Board of Zoning Adjustment
Staff Report
 July 22, 2019

Case No:	19VARIANCE1056
Project Name:	Sycamore Avenue Variance
Location:	2120 Sycamore Avenue
Owner:	Cassandra Culin & Thomas Ellison
Applicant:	Gary Watrous – Watrous Assoc. Architects
Jurisdiction:	Louisville Metro
Council District:	9 – Bill Hollander
Case Manager:	Zach Schwager, Planner I

- **Variance** from Land Development Code section 5.4.1.D.2 to allow a private yard area to be less than the required 30% of the area of a lot.

3. Site Plan

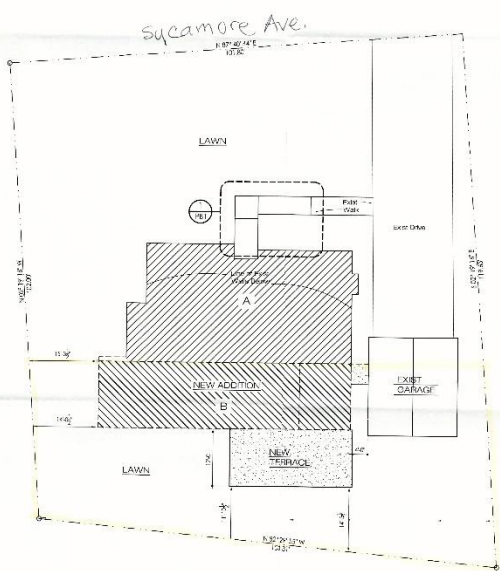
The subject property is zoned R-5B and is in the Traditional Neighborhood Form District. It is located in the Clifton neighborhood and preservation district and contains a one-story single-family residence. The applicant is proposing a one-story addition on the rear of the house. This addition will reduce the private yard area to be less than the required 30% of the area of the lot.

The setback of the house on the lot, 50+ feet from right-of-way, and the size of the addition will require a discretionary variance from the Board of Zoning Adjustment for Private Yard Area. The addition would effectively remove a large portion of the functional private yard; however, staff finds that the nature of the site and design of the addition compliment the existing landscape and wooded features on the lot.

A5	The design of the new addition should be subordinate to the original building. Rear and side additions should not exceed half of the original building's total floor area or building footprint.	+/-	The addition is 850sf and the original structure is 1275sf. The Addition exceeds by approximately 213sf.
